Access Compliance Report

Public Rights-of-Way

Intersection ID: 19130	Main Street: BARCLAY_DOWNS_DR	Cross Street: INVERNESS_RD	Location:	N
ADA ID: 6F898A2F7A22	Ramp Type: PerpDiag	Initial Pass/Fail: Fail	Overall Compliance: No	Severity Score: 26.25
Codes/Mitigation Info/Possible Solution		Field Measurements/Component Compliance

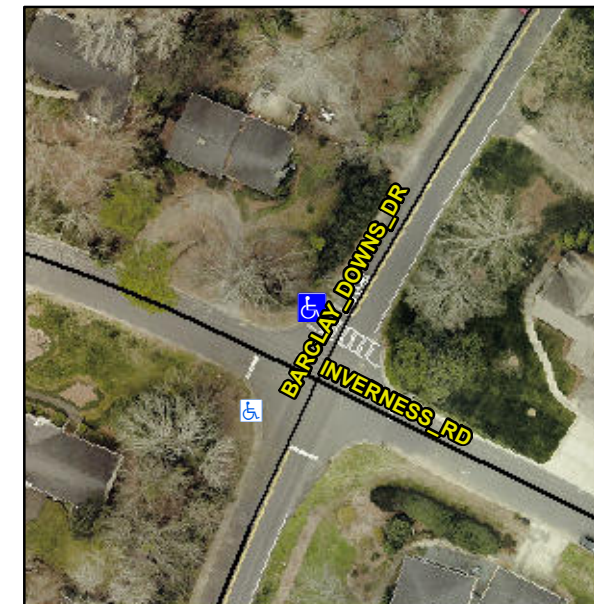
Not Found, R304.2.2, R304.5.3

Compliance	Description	Data	Compliance	Description	Data
N/A	Ramp Length (in)	54.0	No	Ramp Slope (%)	13.5
Yes	Ramp Width (in)	49.5	No	Ramp XSlope (%)	4.1
N/A	Flare Type LT	N/A	N/A	Flare Type RT	N/A
N/A	Flare Slope LT (%)	N/A	N/A	Flare Slope RT (%)	N/A
N/A	Flare Traversable LT?	N/A	N/A	Flare Traversable RT?	N/A
N/A	Landing Length (in)	N/A	N/A	DWS Provided?	N/A
N/A	Landing Width (in)	N/A	N/A	DWS Contrast?	N/A
N/A	Landing Slope (%)	N/A	N/A	DWS Length (in)	N/A
N/A	Landing X Slope (%)	N/A	N/A	DWS Full Width?	N/A
N/A	Landing Curb? (Y/N)	N/A	N/A	DWS Offset (in)	N/A
N/A	Shared Landing?	N/A			
N/A	Gutter Ponding?	N/A	N/A	Gutter Slope (%)	N/A
N/A	Gutter Lip Ht (in)	N/A	N/A	Gutter X Slope (%)	N/A
N/A	Painted X Walk1?	No	N/A	Painted X Walk2?	Yes
	X Walk 1 Direction	To SW		X Walk 2 Direction	To SE
N/A	X Walk 1 Width (in)	N/A	N/A	X Walk 2 Width (in)	111.5
	X Walk 1 Slope (%)	5.9		X Walk 2 Slope (%)	3.4
	X Walk 1 X Slope (%)	5.0		X Walk 2 X Slope (%)	6.5

Remove & Replace Curb Ramp With Two New Directional Ramps or Equivalent.
